Public Market - Parcel B

Emeryville Planning Commission Hearing

JANUARY 24, 2019

Design Changes

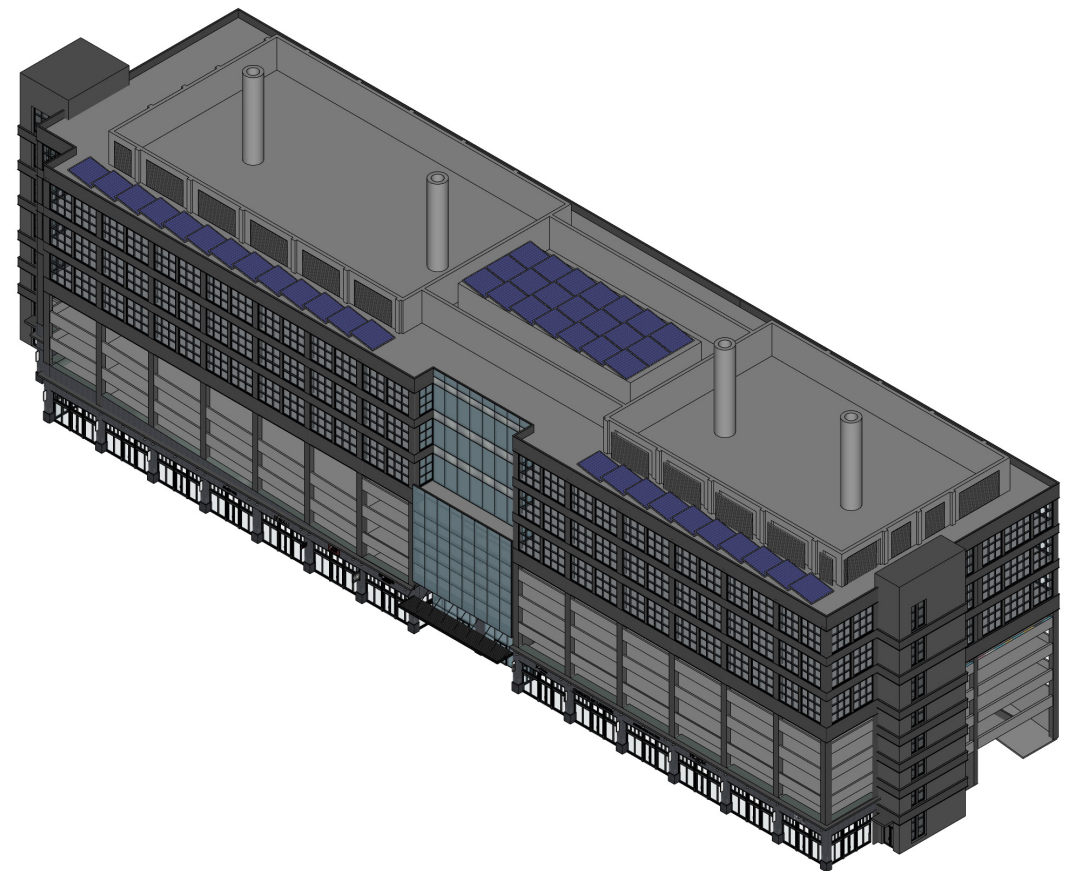
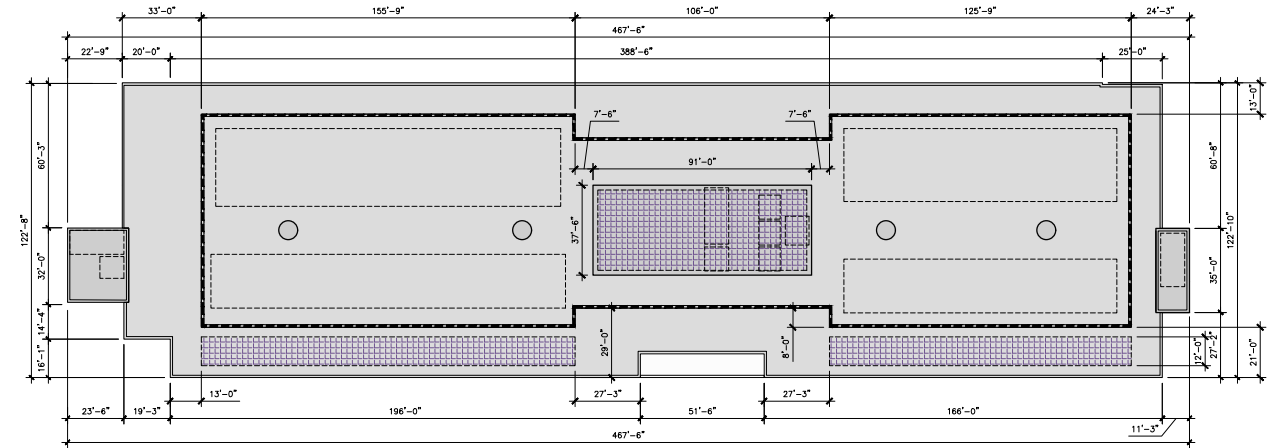
1. Consider adding solar/PV panels
2. Consider adding EV parking spaces
3. Provide servicing to retail areas from the back
4. Treat the West and East facades as equivalent fronts
5. Develop the Vertical circulation towers and add windows to the stairs
6. Develop the landscape design
7. Provide more detail on the retail storefronts

1. PV / Solar panels added at roof level.

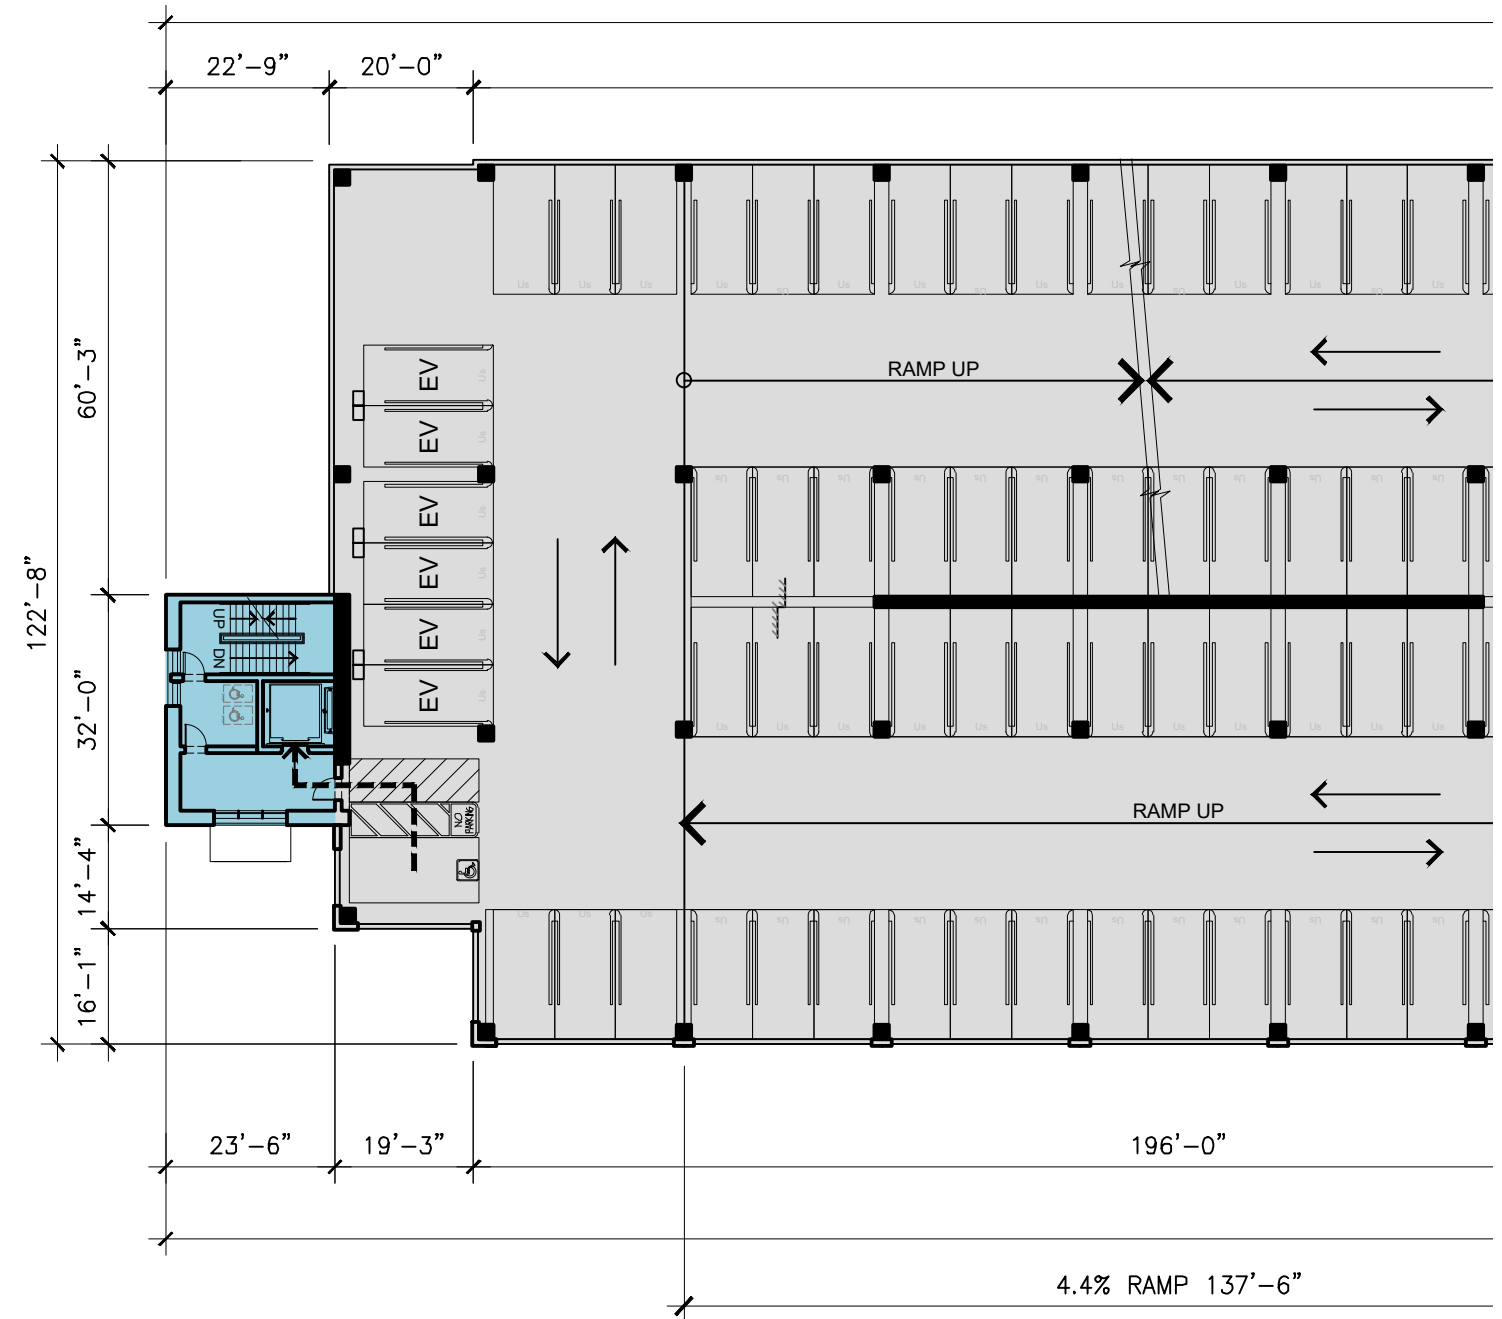
1. Consider adding solar/PV panels
2. Consider adding EV parking spaces
3. Provide servicing to retail areas from the back
4. Treat the West and East facades as equivalent fronts
5. Develop the Vertical circulation towers and add windows to the stairs
6. Develop the landscape design
7. Provide more detail on the retail storefronts

1. Electric Vehicle (EV) spaces added / identified at Levels 2, 3 and 4.

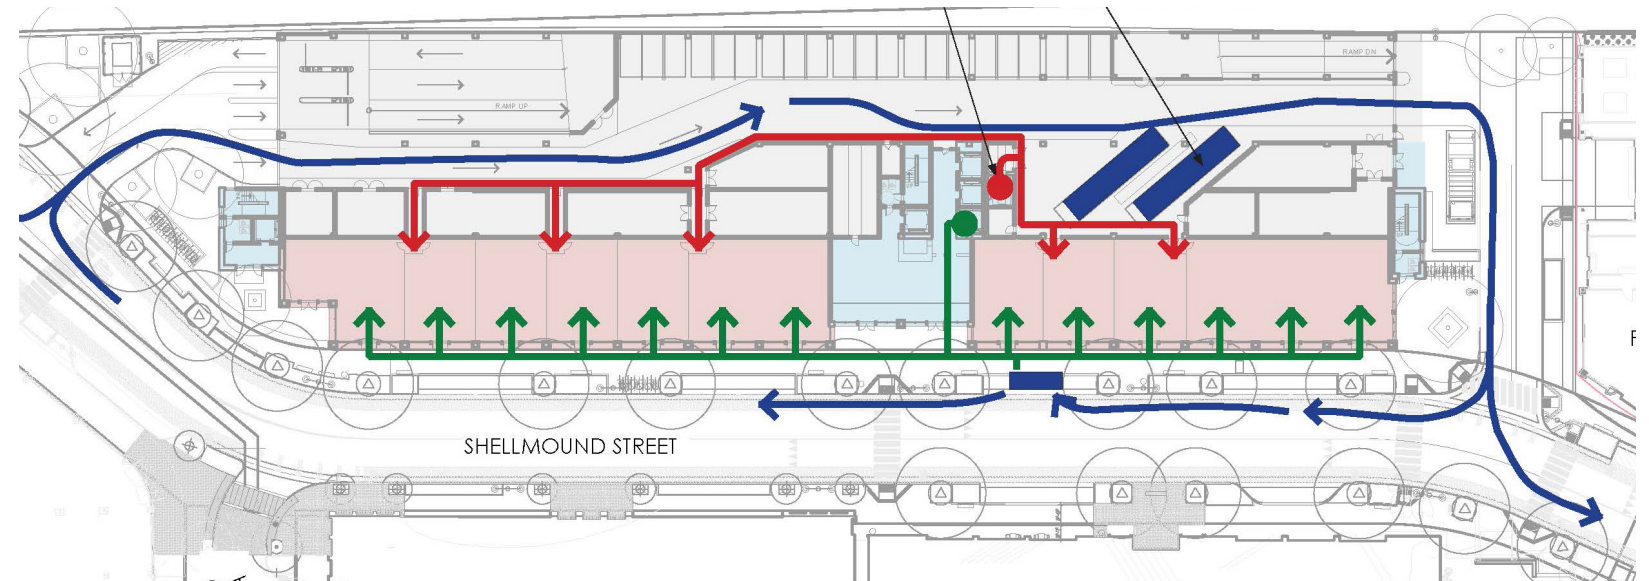
1. Consider adding solar/PV panels
2. Consider adding EV parking spaces
3. Provide servicing to retail areas from the back
4. Treat the West and East facades as equivalent fronts
5. Develop the Vertical circulation towers and add windows to the stairs
6. Develop the landscape design
7. Provide more detail on the retail storefronts

1. Primary servicing access provided from the back.
2. Limited secondary deliveries still expected from delivery trucks by the streetfront.

West Facade

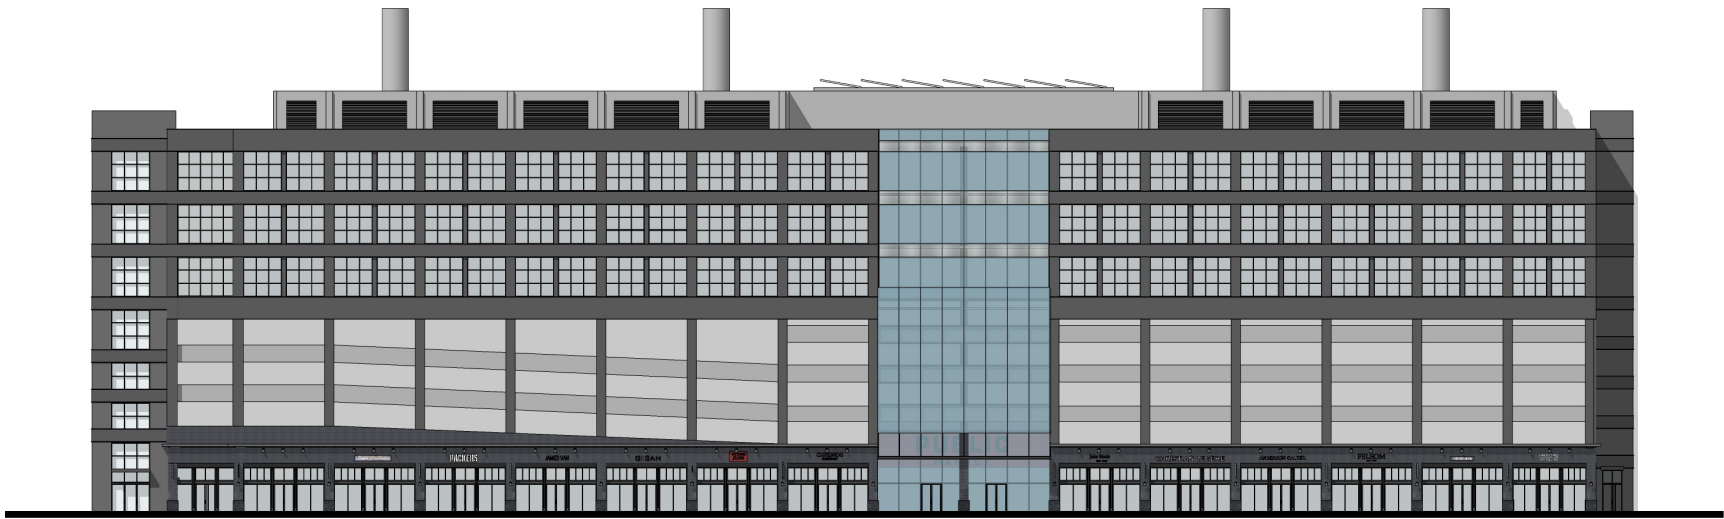
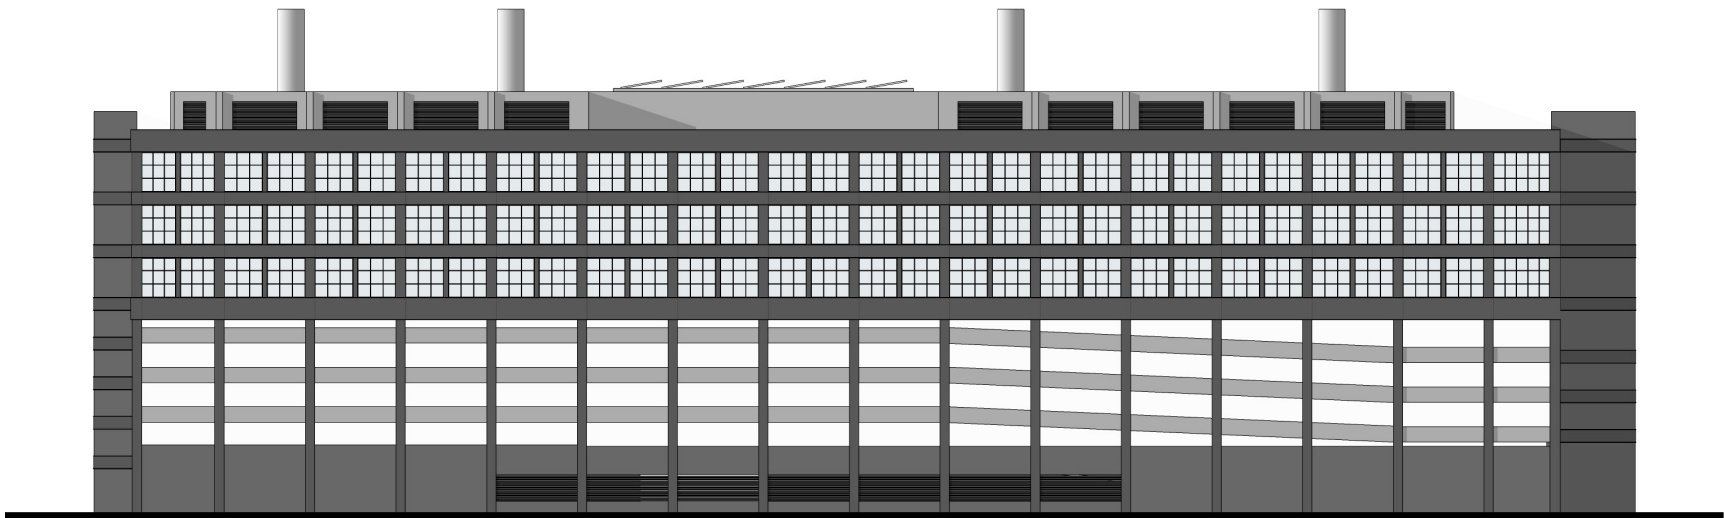
- 1. Consider adding solar/PV panels
- 2. Consider adding EV parking spaces
- 3. Provide servicing to retail areas from the back
- 4. Treat the West and East facades as equivalent fronts
- 5. Develop the Vertical circulation towers and add windows to the stairs
- 6. Develop the landscape design
- 7. Provide more detail on the retail storefronts

- 1. Size, proportion, quality of windows and wall system at lab levels
- 2. Size and proportion of expressed frame system at all levels
- 3. Articulation of roofscape elements
- 4. Open parking level design and expression
- 5. Generally limited articulation in the massing.

- 1. Glass wall notch at Main Entry
- 2. Storefronts facing Shellmound Street

C. NORTH ELEVATION

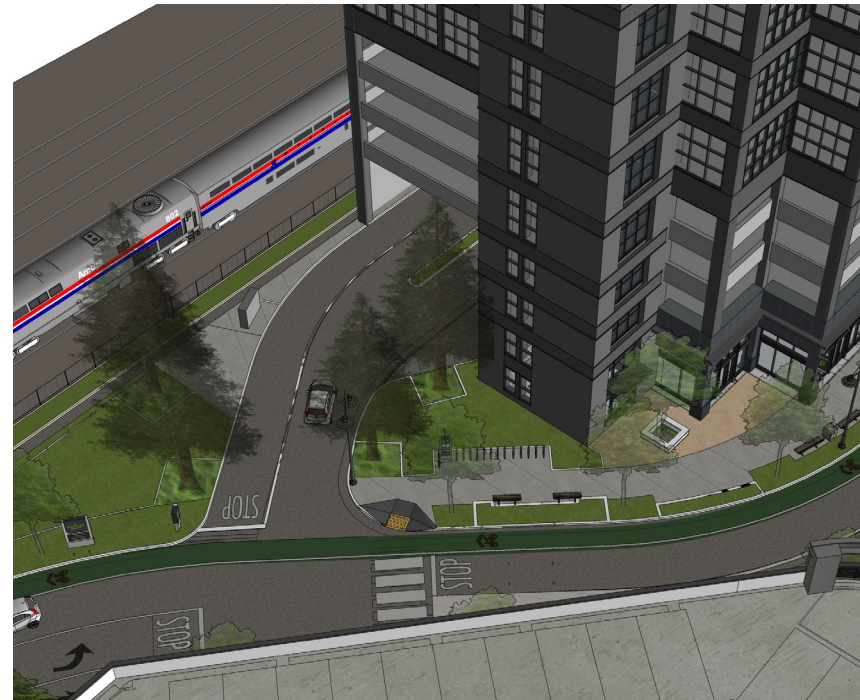
1. Consider adding solar/PV panels
2. Consider adding EV parking spaces
3. Provide servicing to retail areas from the back
4. Treat the West and East facades as equivalent fronts
5. Develop the Vertical circulation towers and add windows to the stairs
6. Develop the landscape design
7. Provide more detail on the retail storefronts

1. Windows added to stairs
2. Horizontal articulation added similar to building facades
3. South tower consolidated and reduced in size

NORTH OPEN AREA NEAR PARCEL C / CROSSWALK

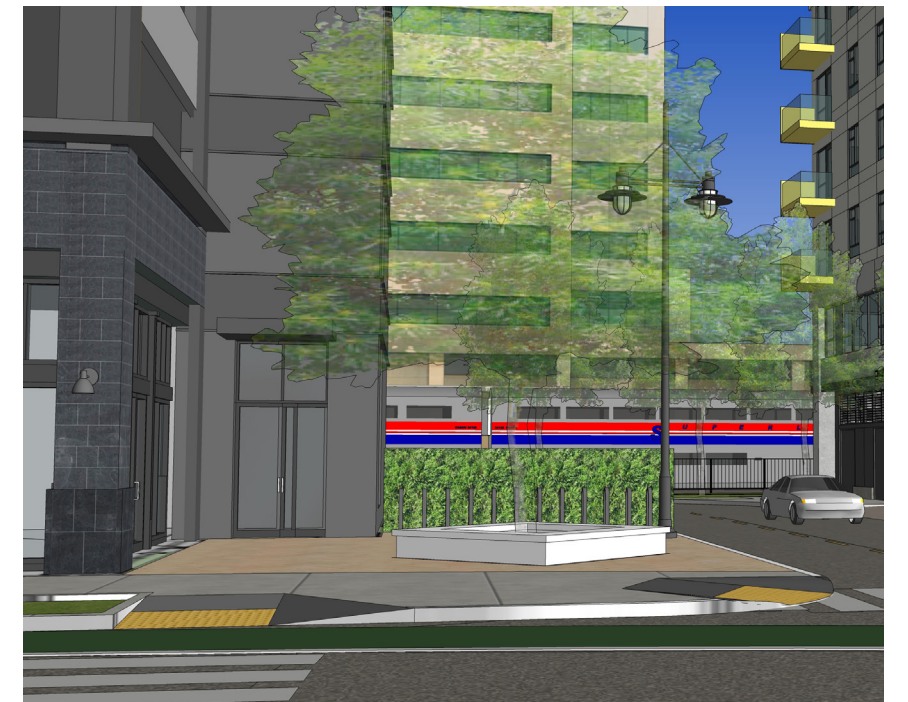
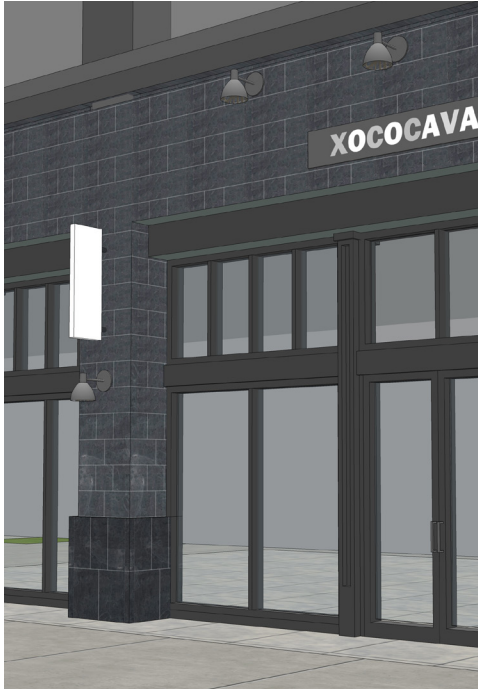
1. Consider adding solar/PV panels
2. Consider adding EV parking spaces
3. Provide servicing to retail areas from the back
4. Treat the West and East facades as equivalent fronts
5. Develop the Vertical circulation towers and add windows to the stairs
6. Develop the landscape design
7. Provide more detail on the retail storefronts

1. Open space design developed
2. Trees with seat walls added at building setbacks
3. Planting added to soften open space / transition at base of bulging / vertical circulation cores
